REMARKS

Claims 1-25 are pending in the present application. The Examiner has rejected claims 1-7, 9-13, and 15-25 and objected to claims 8 and 14. Further, the Examiner has objected to the drawings and the specification of the applications. Applicants have amended the drawings and specification as indicated by the Examiner. Further, Applicants have amended claims 1 and 19 to clarify the invention and claims 8 and 14 as suggested by the Examiner. No new matter has been added by these amendments.

Fig. 1 (Prior Art)

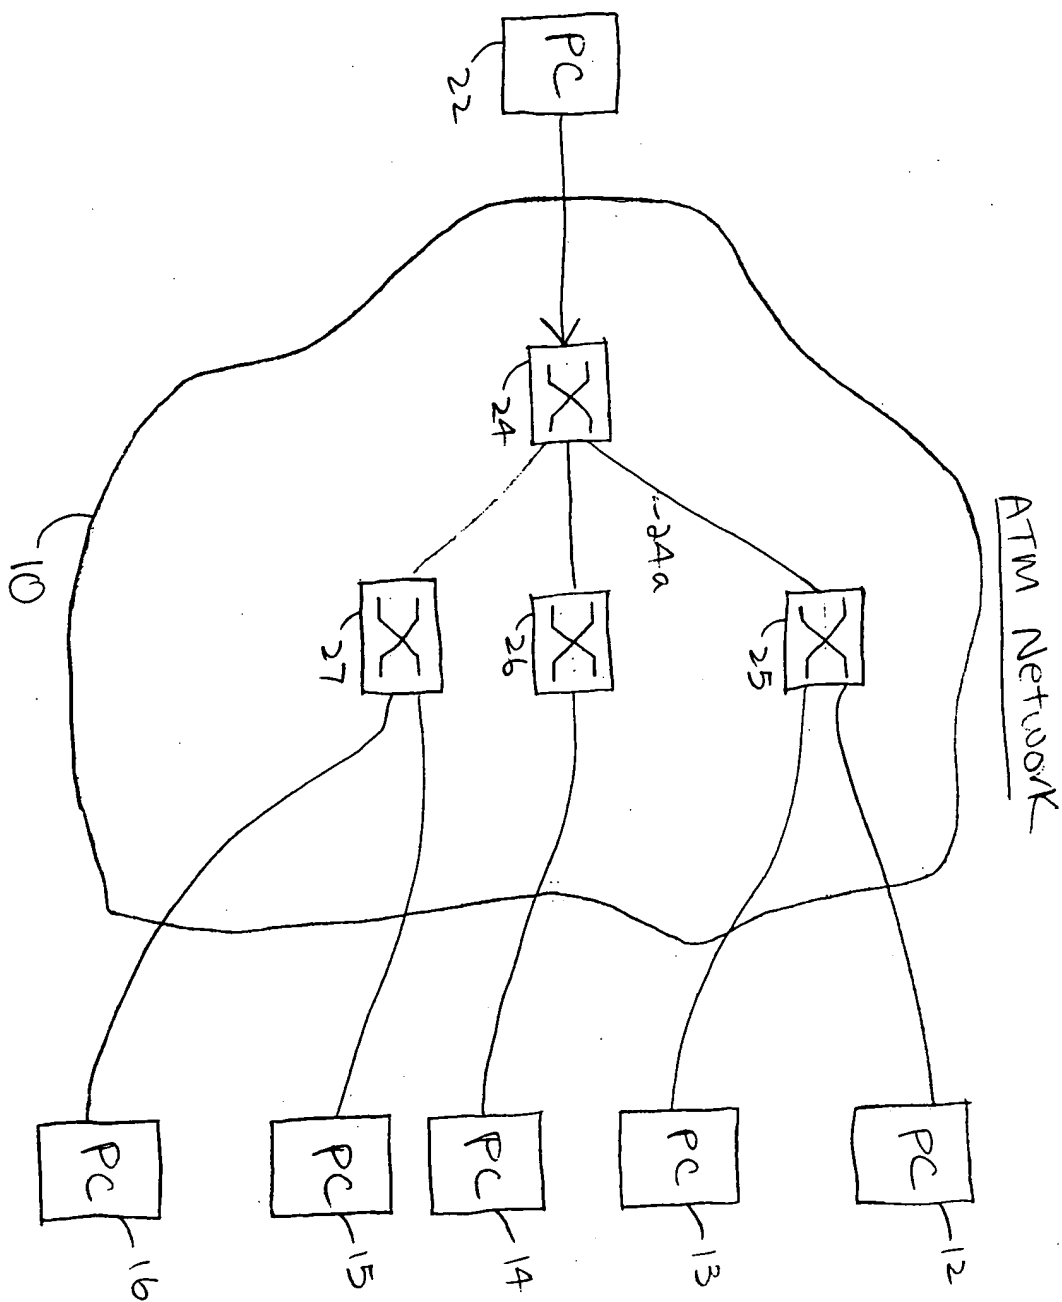
The Examiner has objected to the drawings. In particular, the Examiner has indicated that Figures 1-4 should be labeled with the legend --Prior Art-- “because only that which is old is illustrated.” Further, the Examiner has indicated that Figure 1 includes a reference sign, sign “24a,” that was not mentioned in the description. Also, the Examiner has indicated that the description describes a reference number 34 that is not included in the Figures.

As indicated above, Figures 1-4 have been amended to include the legend --Prior Art--. Further, Figure 2 has been amended to include indication of element “34.” The reference to element 24a of Figure 1 is included in the specification on line 6 of page 20; therefore, no amendment to Figure 1 with respect to the element “24a” is made.
